A10 Stoke Newington Gyratory Gyratory Removal

Stage 1 Road Safety Audit

Ref: 3201/004/A10/TLRN/2018

Problem Locations

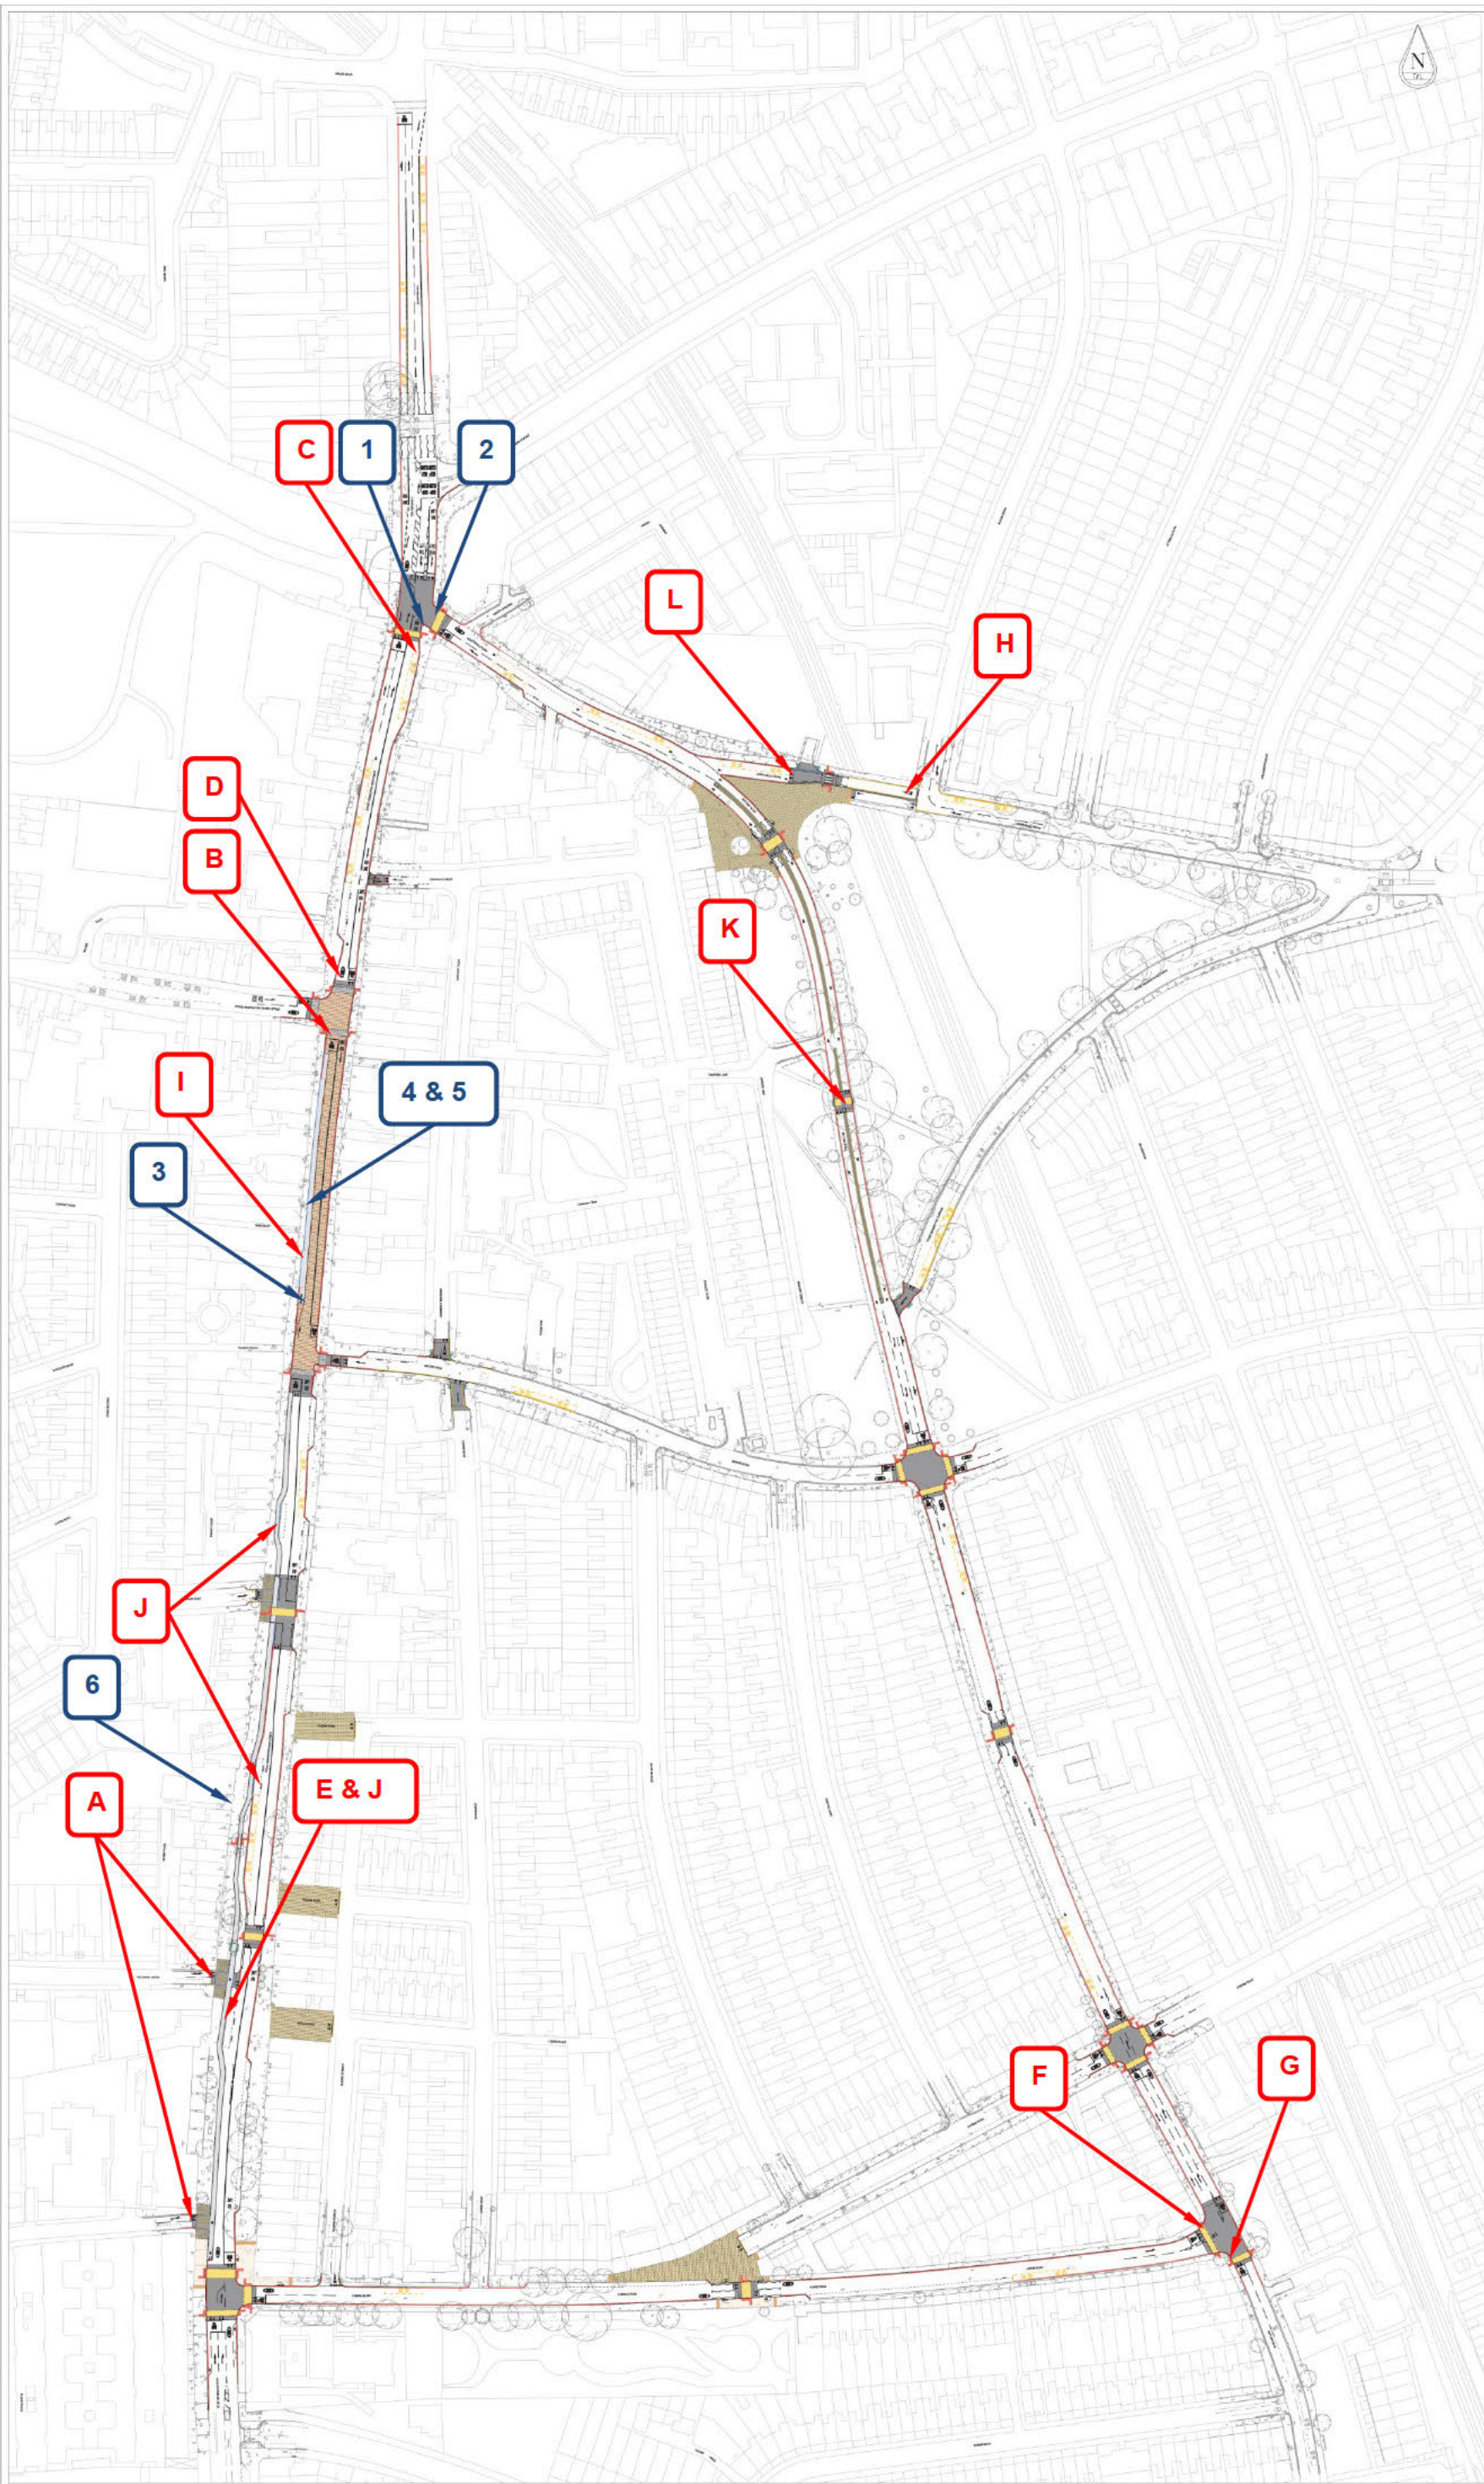
Location: A – Victorian Grove and Victorian Road junction with Stoke Newington High Street, continuous footways.

Summary: The two-way operation of the minor arm may reduce the likelihood of drivers giving way to pedestrians / cyclists at the junction. This could result in an increased risk of collisions between pedestrians / cyclists and vehicles turning left from Stoke Newington High Street.

Location: B – Stoke Newington High Street northbound, junction with Stoke Newington Church Street.

Summary: Drivers turning left into Stoke Newington Church Street may not appreciate that cyclists have re-joined the carriageway from the stepped track. This may result in left hook type collisions.

Location: C – Stoke Newington High Street northbound, junction with Northwold Road.

Summary: Stationary traffic may obstruct visibility to the nearside primary traffic signal. Drivers may fail to see the traffic signals. This may result in red light violations or nose to tail type collisions.

Location: D – Stoke Newington High Street northbound, junction with Stoke Newington Church Street.

Summary: Lane widths on the northbound exit of the junction could cause cyclists to be squeezed by passing vehicles. This may result in side swipe type collisions.

Location: E – Stoke Newington High Street junction with Victorian Grove.

Summary: Vehicles in the loading bay may restrict intervisibility between drivers turning left into Victorian Grove and northbound cyclists. This may result in left hook type collisions.

Design Organisation Response	Accepted / Part Accepted / Rejected
<p>The design team has previously investigated restricting turning manoeuvres at both junctions, however it is not practical to make all roads joining onto the high street exit only. There is a Police Station located along Victoria Road which requires quick vehicular access to and from Stoke Newington High Street during emergency calls, making the conversion of Victoria Road one-way out impractical. Furthermore, the borough do not support new one-way streets, meaning that the existing two-way operation has been retained for Victoria Grove.</p> <p>The Highway Code is clear in that pedestrians and cyclists should have priority over traffic at side roads. High streets should be road environments where pedestrians and cyclists have priority over all other traffic, which in the case of side roads, is already supported by Rules 170, 183 & 206 of the Highway Code. Continuous</p>

Design Organisation Response	Accepted / Part Accepted / Rejected
Width constraints have forced the early termination of the stepped track, prohibiting the track to be continued further north of Stoke Newington Church Street.	
An early cycle release was investigated and modelled for the northbound junction approach, though the traffic modelling showed that the impacts on congestion and bus journey time delays along the high street were unlikely to be acceptable to get scheme approval.	
The design will be altered to include the slight shortening of the stepped track and providing an on-carriageway feeder lane into the ASL. The proposed ASL will enable cyclists to position themselves ahead of waiting traffic when held on red.	
The design team will also investigate whether an advisory cycle lane could be provided on the northbound junction exit, therefore protecting cyclists until a safer merger point further north.

Design Organisation Response	Accepted / Part Accepted / Rejected
Opportunities to relocate the bus stops are limited, as the length of the cages have been determined by the number of services accessing the stops as well as the required entry and exit tapers.	
The bus cage on the southbound junction exit has been relocated further south, which should minimise the risk of buses tailing back through the junction. In addition, a new traffic island has been proposed on the northbound approach which will allow the location of an offside primary traffic signal.	
A far sided secondary signal is proposed on the northbound approach, whilst closely associated secondary traffic signals will be proposed on the southbound junction approach.	
The changes outlined above should ensure the traffic signals are appropriately visible on the junction approaches.	
Client Organisation Comments	
Accepted	Client agrees with designer

Design Organisation Response	Accepted / Part Accepted / Rejected
An early cycle release was investigated and modelled for the northbound junction approach, though the traffic modelling showed that the impacts on congestion and bus journey time delays along the high street were unlikely to be acceptable to get scheme approval.	
The design will be altered to include shortening of the stepped track and providing an on-carriageway feeder lane into the ASL. The proposed ASL will enable cyclists to position themselves ahead of waiting traffic when held on red.	
The western kerbline will also be realigned to provide a 3.0m wide northbound traffic lane alongside a 1.5m advisory cycle lane up to the junction with Garnham Street.	
Client Organisation Comments	
Part accepted	
Early starts are not mandatory for asl's, The proposed ASL will enable cyclists to position themselves ahead of waiting traffic when held on red.

Design Organisation Response	Accepted / Part Accepted / Rejected
The design will be amended to realign the cycle track along the offside (carriageway side) of the inset bay, therefore ensuring cyclists will not be obstructed by loading vehicles for traffic turning left into Victoria Grove.	
Client Organisation Comments	
Accepted	Agree with designer
